**Re: PCD File No. PPR2329  
The Rock Commerce Center, 2nd Review  
Response to Comments**

Please accept this letter on behalf of Central Development, LLC, the applicant for The Rock Commerce Center. We received your comment letter dated December 8, 2023, regarding the application and we offer the following responses:

**THE ROCK COMMERCE CENTER**  
**SITE DEVELOPMENT PLAN**  
GRADING PLAN

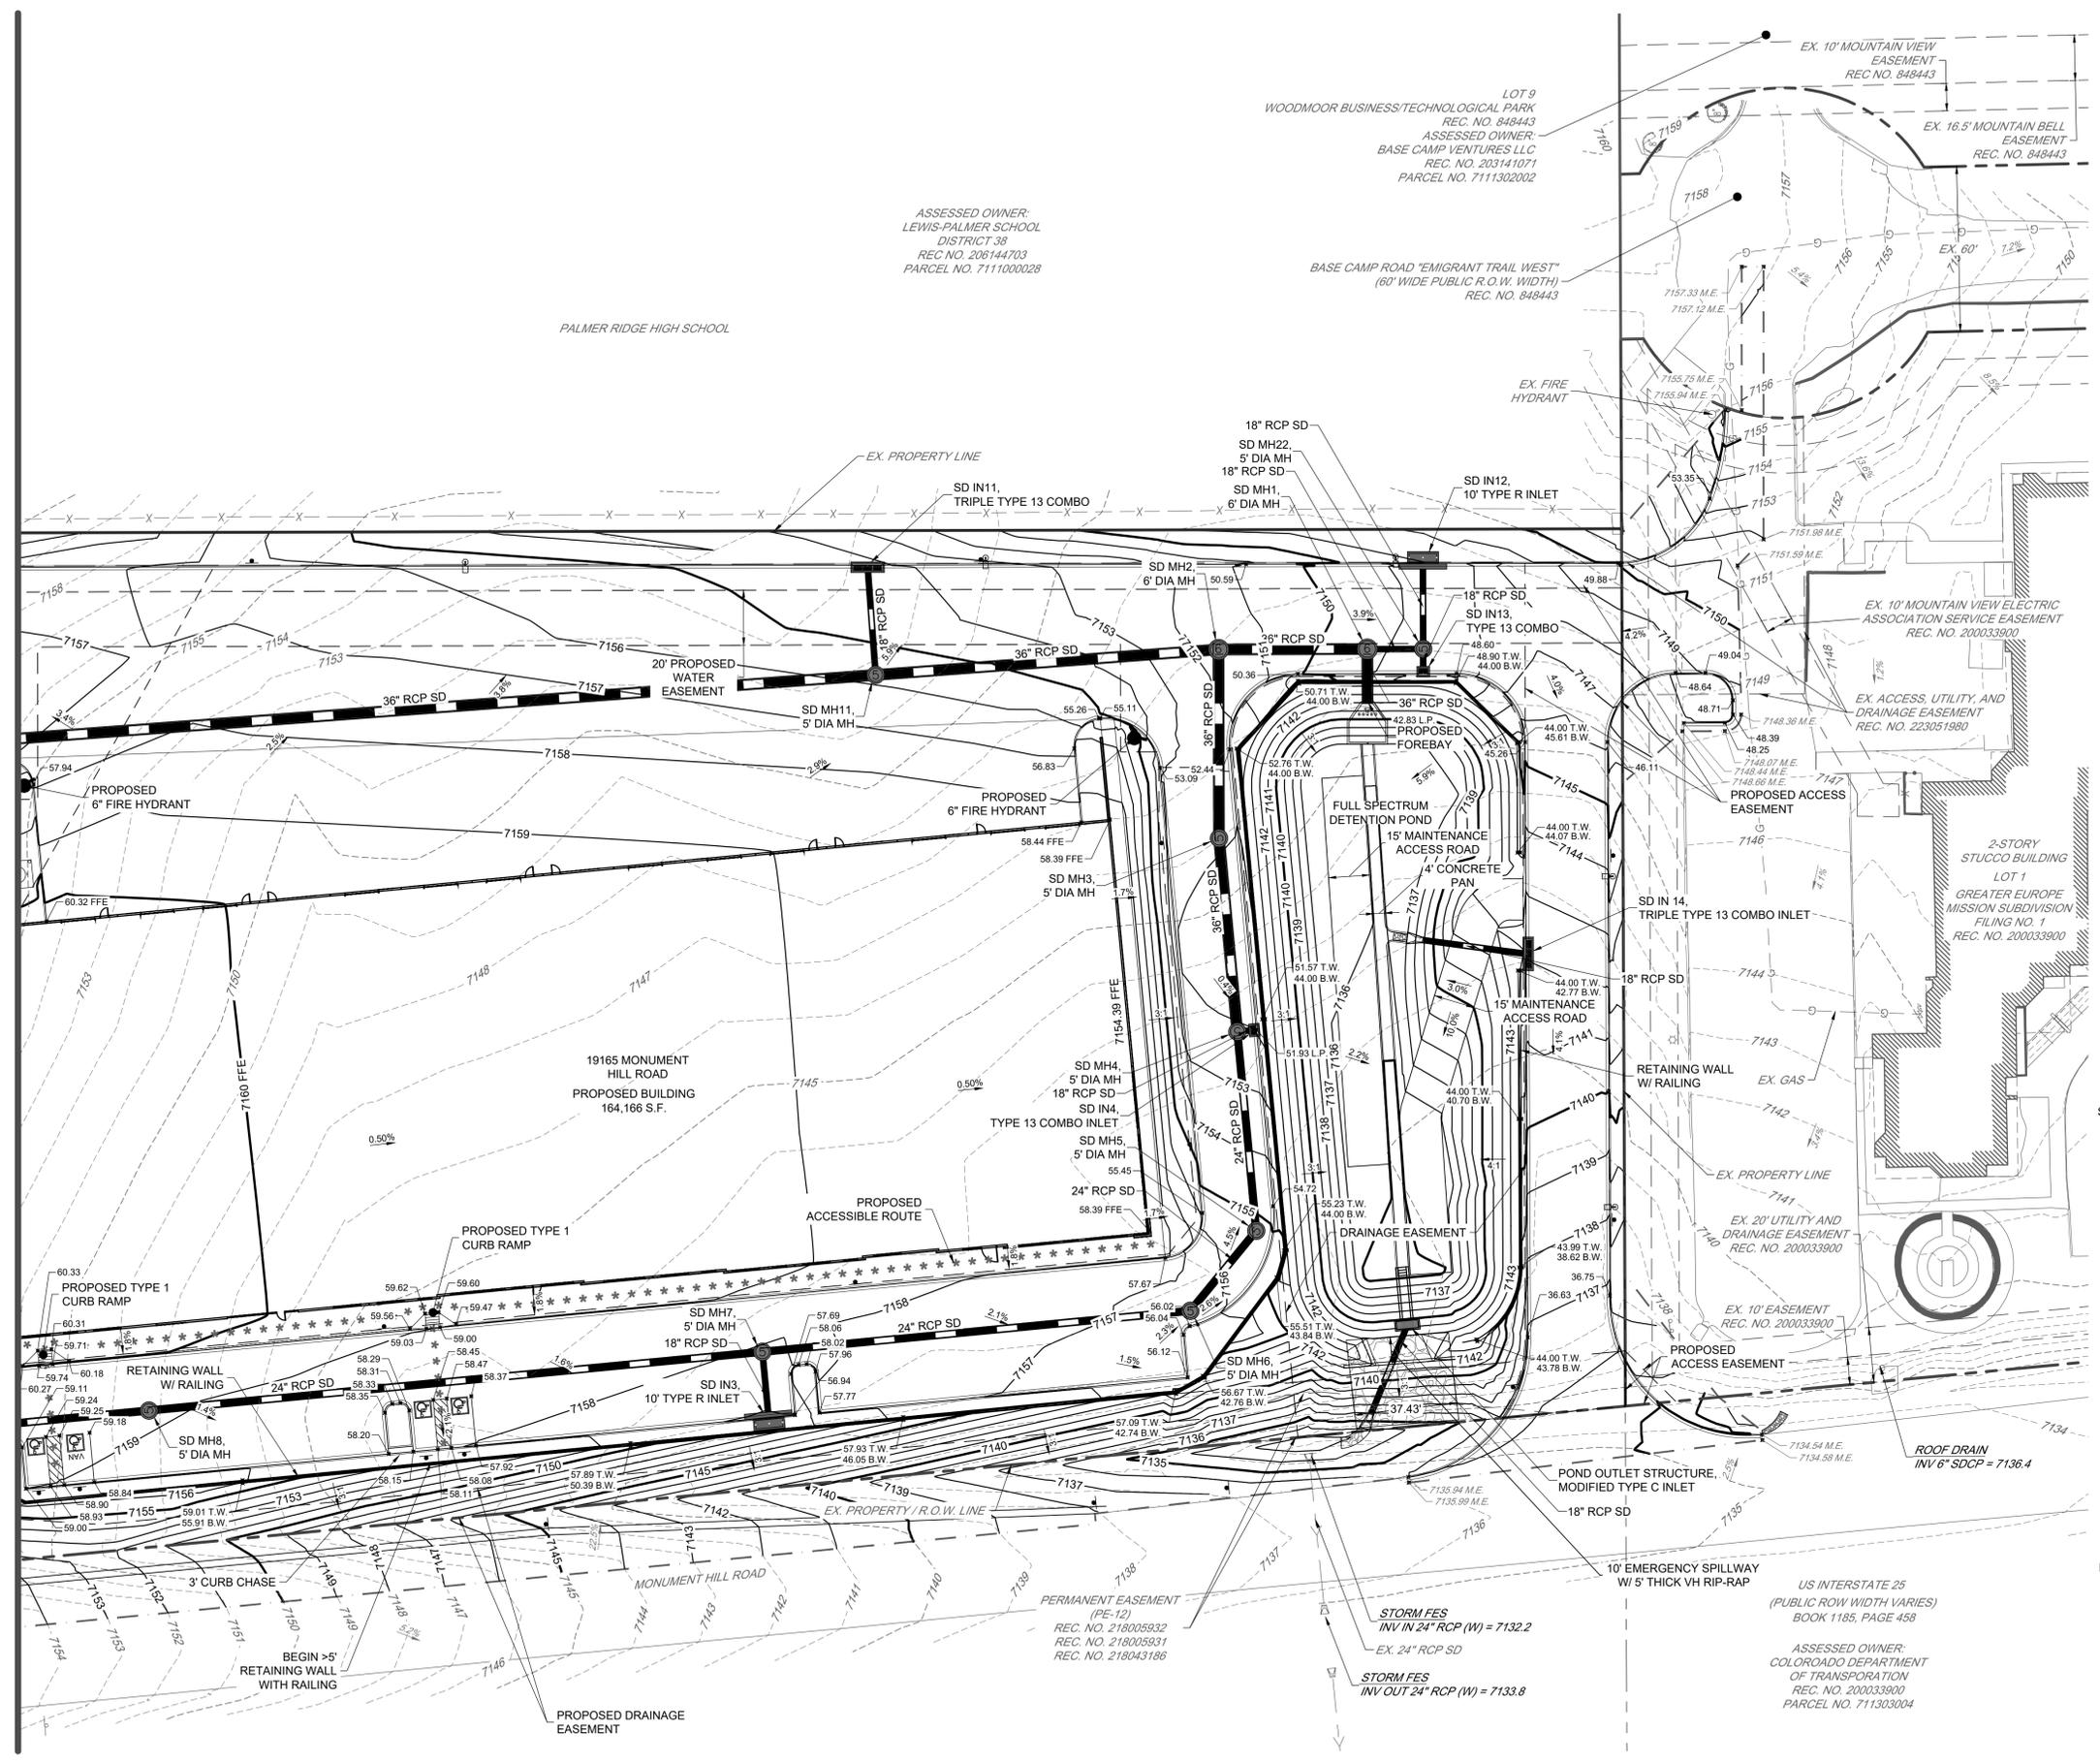
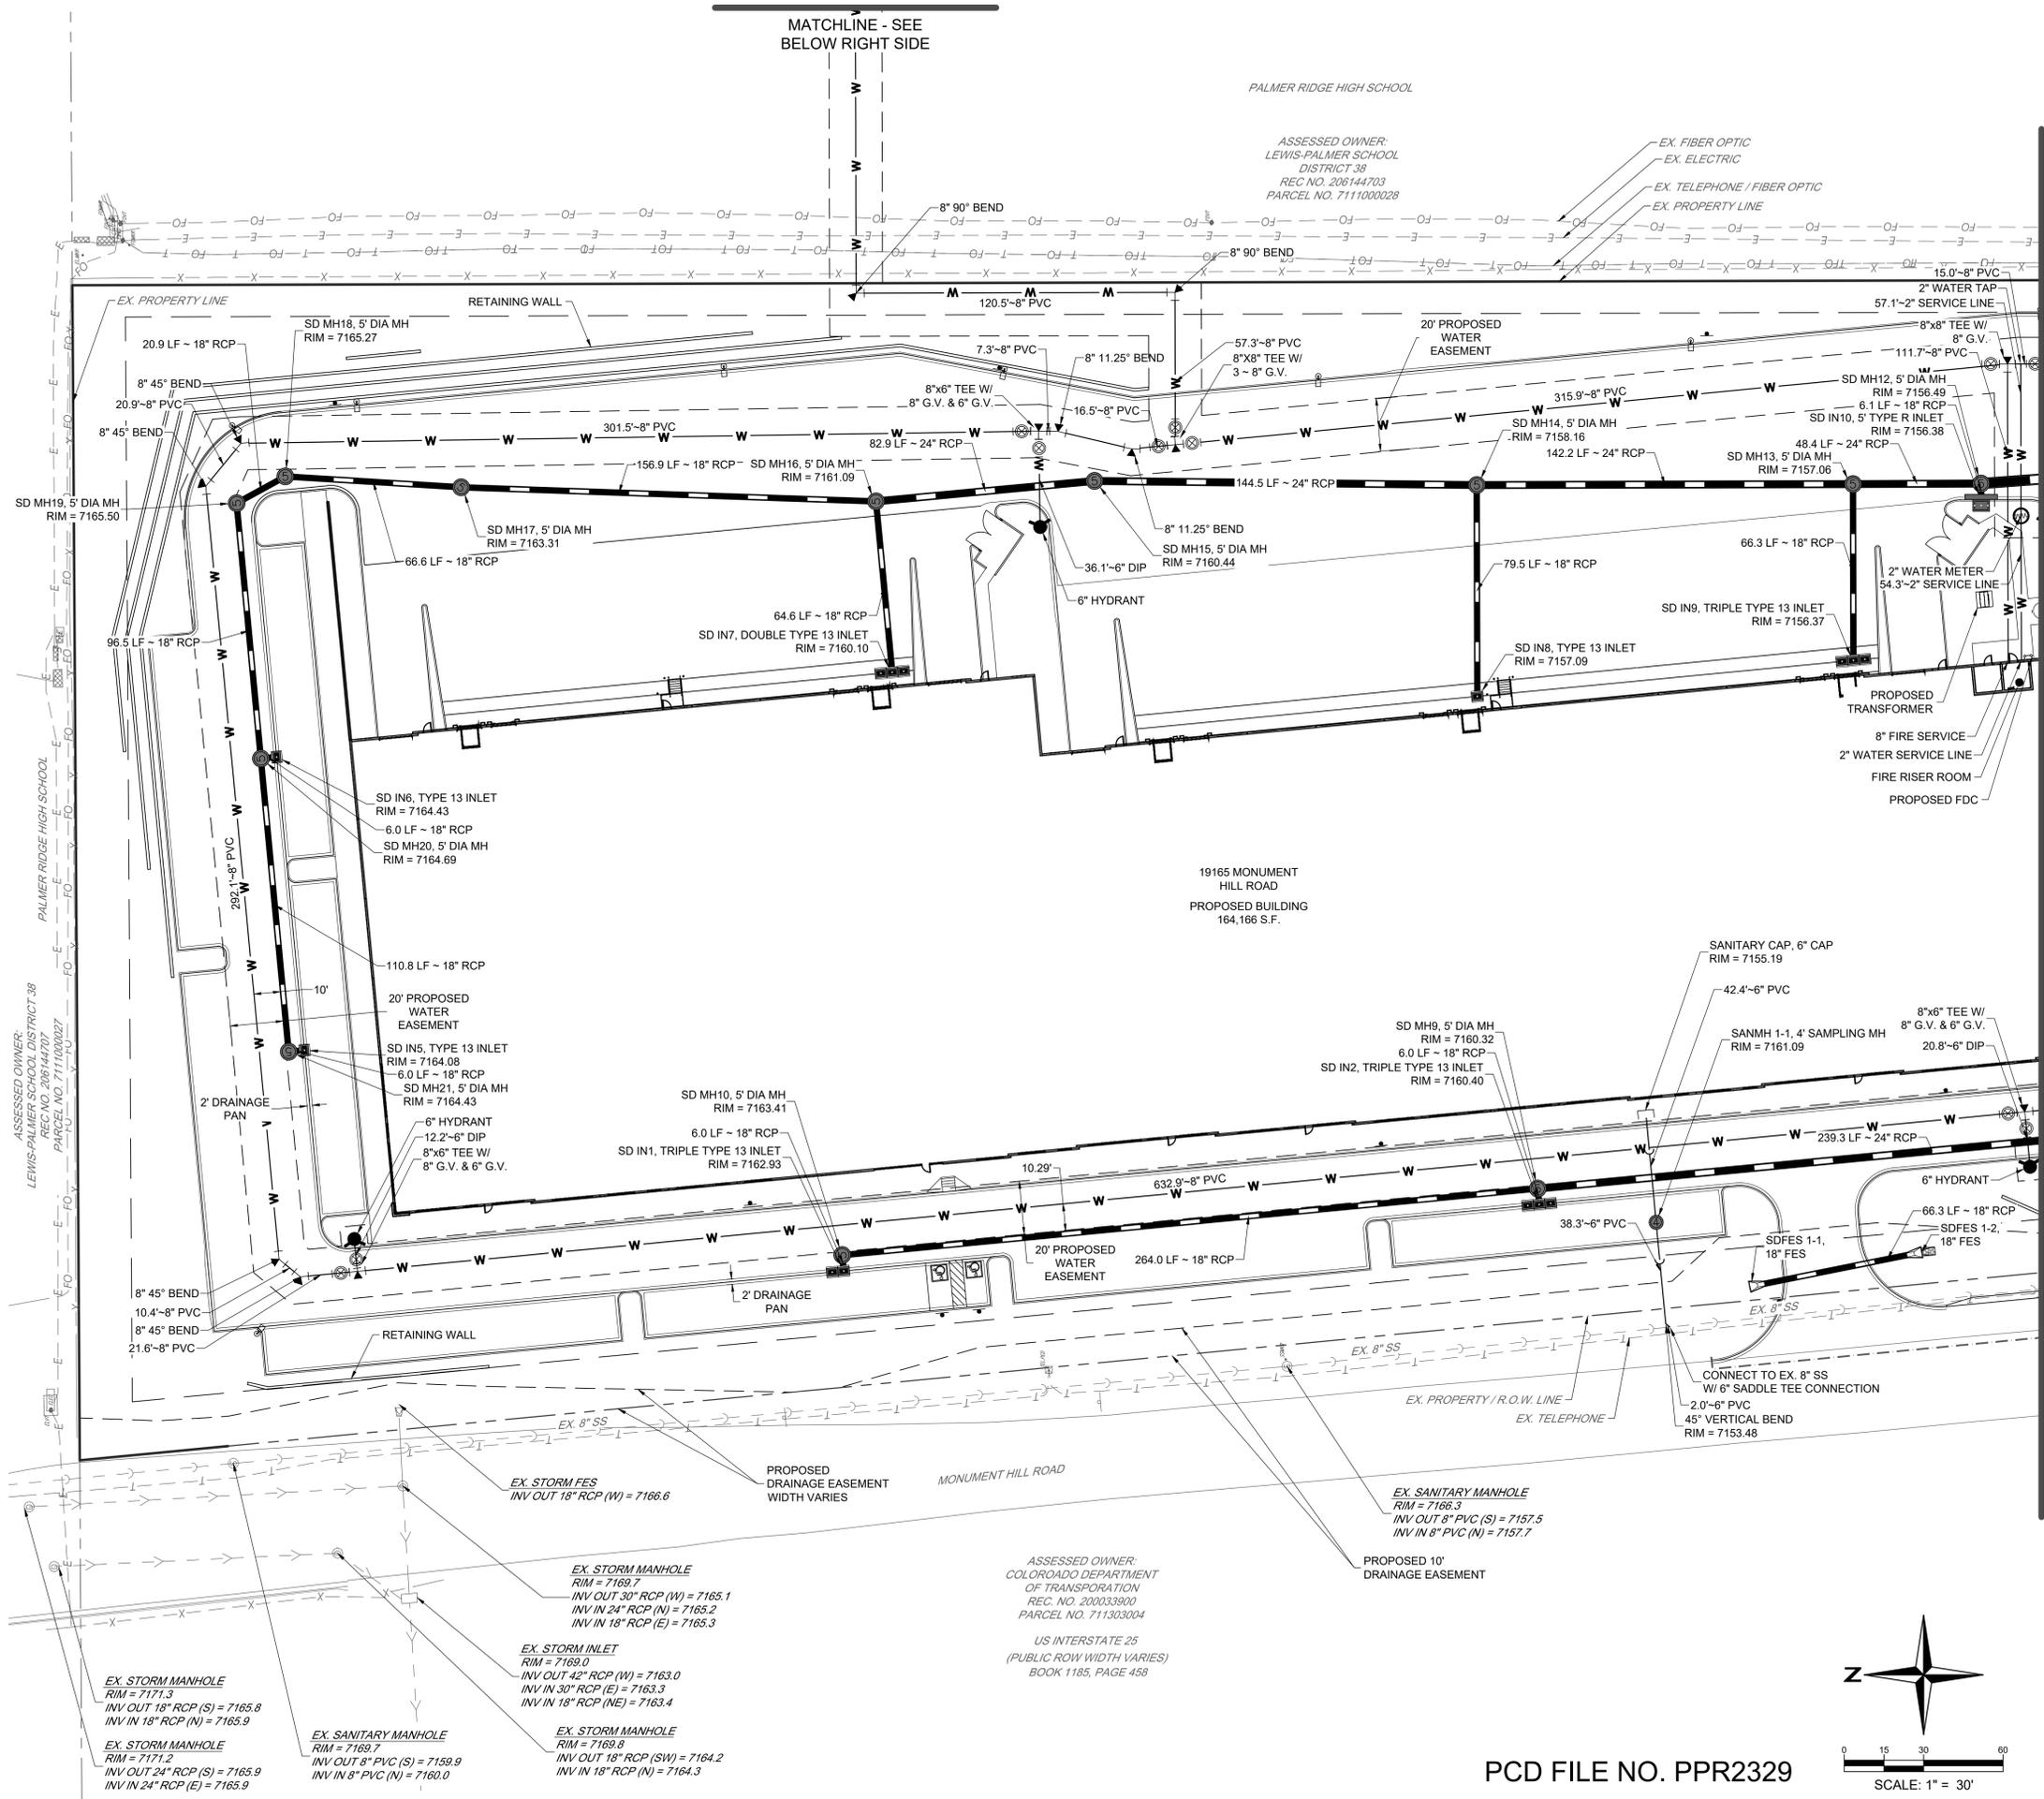
Sheet 5-6, Grading Plan – Responses were prepared by Redland

1. Wall will need drainage pan to direct flows around and not over wall. Refer to County detail SD\_3-44. Provide calculation for sizing of ditch section in drainage report.

**Response:** A drainage pan was added to direct flows around the walls and the County detail was added to the SDP set. An SF table and flow calculations were added to the Drainage Report for sizing of the drainage pan.

SHEET  
**C3.0**

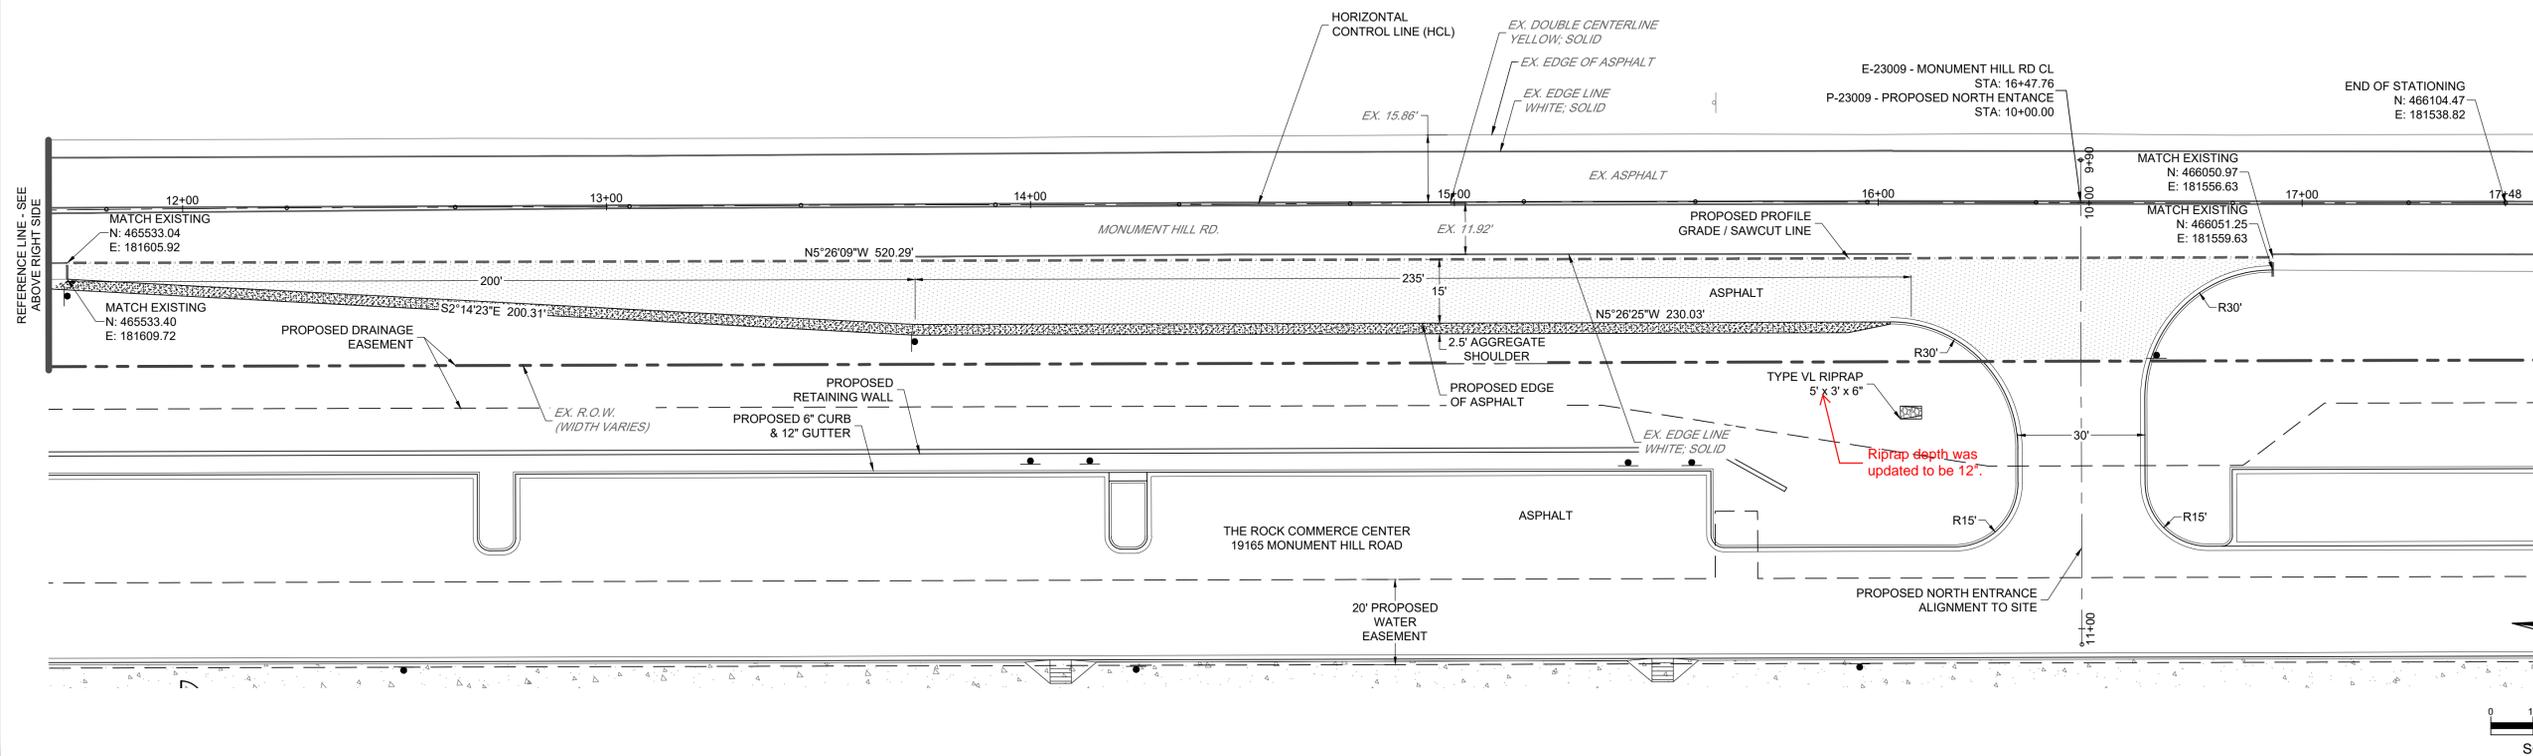
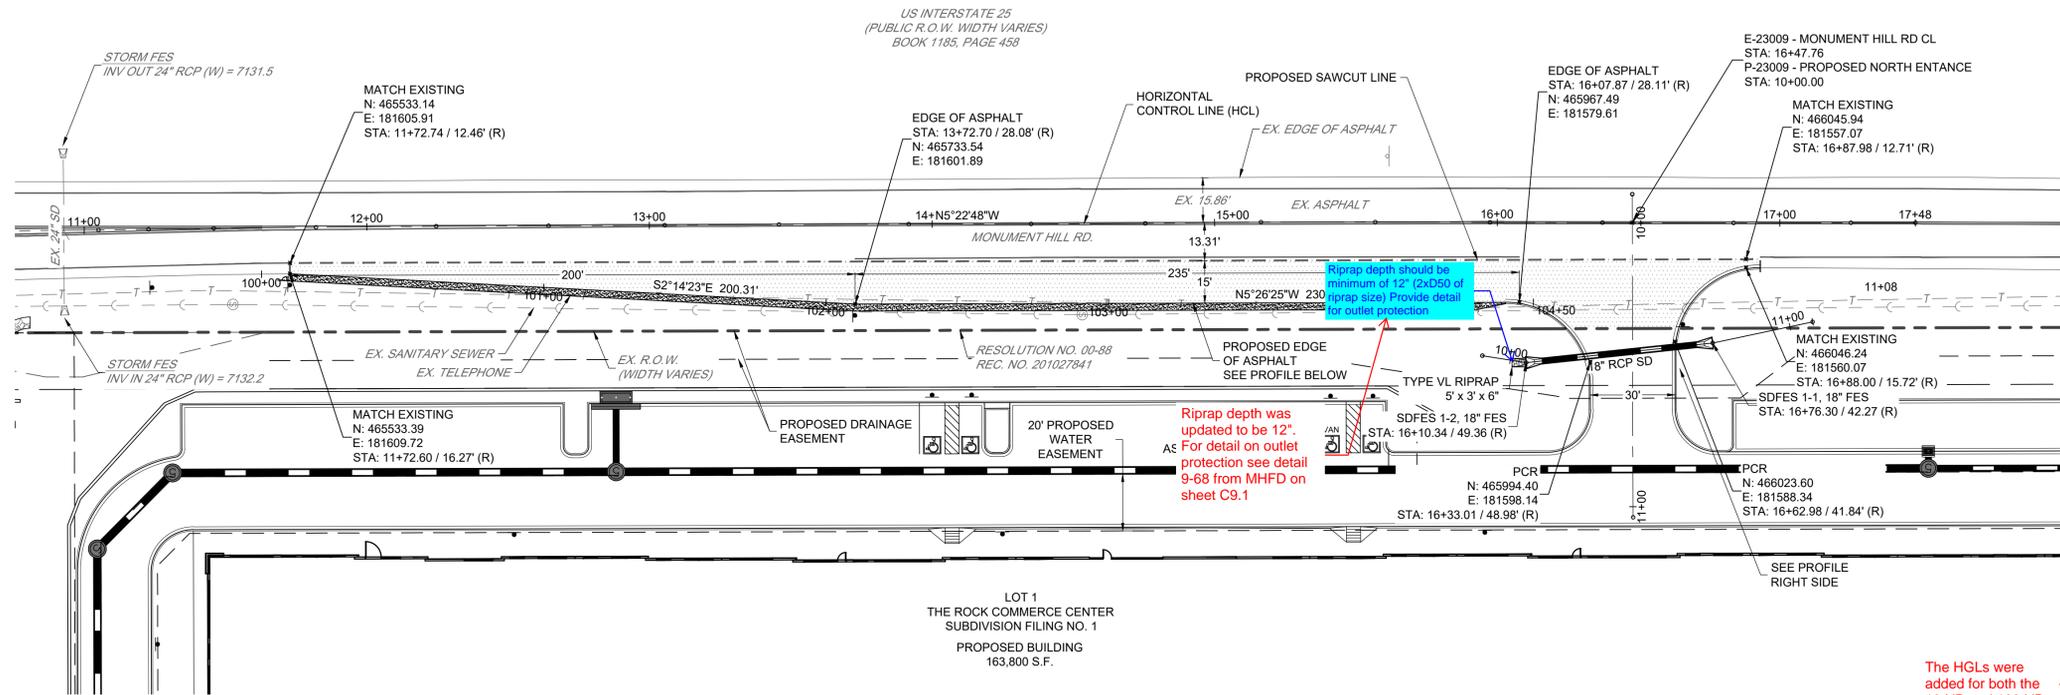
2. Riprap depth should be minimum of 12" (2xD50 of riprap size).

**Response:** The riprap was all updated to be 12" deep on all plans.
